SUBJECT: PURDUE UNIVERSITY - REQUEST FOR ADDITIONAL INFORMATION REGARDING
THE PURDUE UNIVERSITY REACTOR LICENSE RENEWAL (TAC NO. ME 1594),
RESPONSES TO RAIs DATED 6 JULY 2011 (ML101460429)

**REQUESTED ADDITIONAL INFORMATION IN RESPONSE TO RAIs DATED 6 JULY 2011
(ML101460429)**

REGARDING THE PURDUE UNIVERSITY REACTOR LICENSE RENEWAL (TAC NO. ME 1594)

FIGURE 6.1: PUR-1 Organization

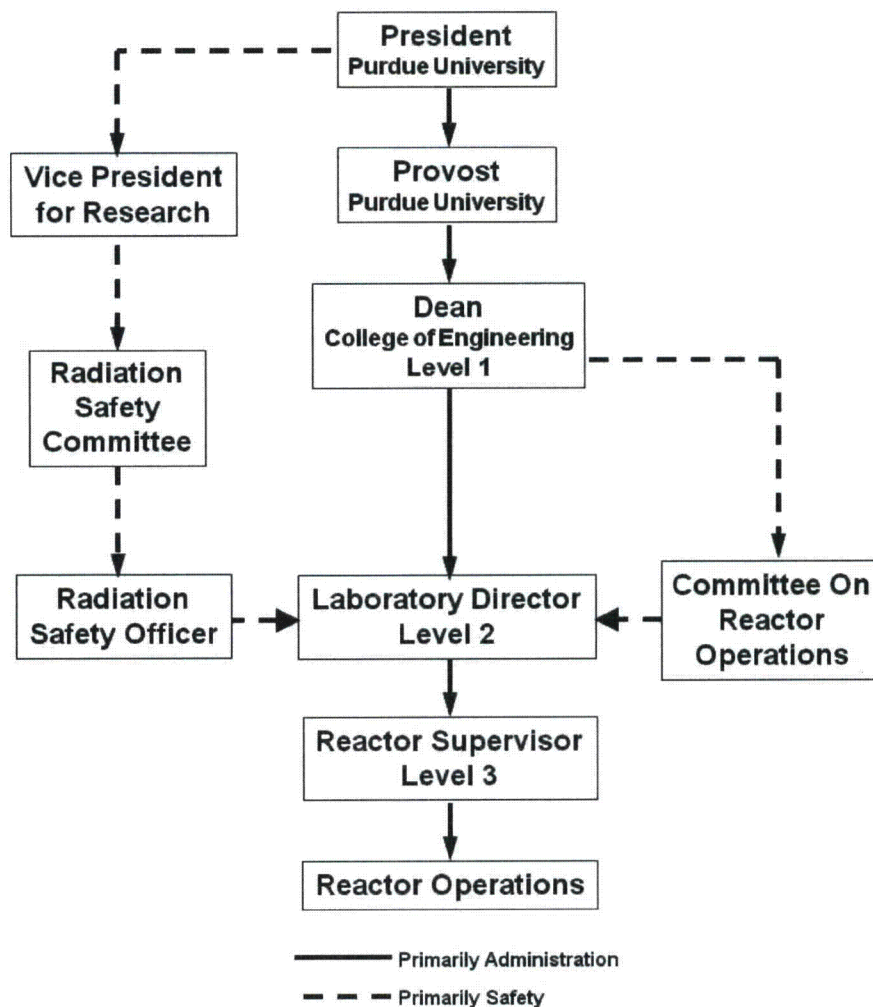
37. PUR-1 Organization: Neither Figure 6.1 nor TS 6.1.5 clearly indicate the organizational level of the Head of Nuclear Engineering. Please update the figure and/or TS to reflect the level of authority for the Head of the school of Nuclear Engineering or justify why it is not required.

The NE department head was in the original organization chart from the 1988 license, which predated the licensee levels specified in ANSI 15.1. Since the organization has been changed to reflect the ANSI 15.1 style license levels, we have removed the NE department head from the organization chart, and TS 6.1.5 has been modified as follows:

In all matters pertaining to the operation of the reactor and the administrative aspects of these technical specifications, the Laboratory Director (Level 2) [or the Reactor Supervisor (Level 3) in the absence of the Laboratory Director] shall report to and be directly responsible to the Level 1 Licensee, the Dean of the College of Engineering. In all matters pertaining to radiation safety they shall be responsible to the Radiation Safety Committee.

Figure 6.1 has been modified to reflect that change.
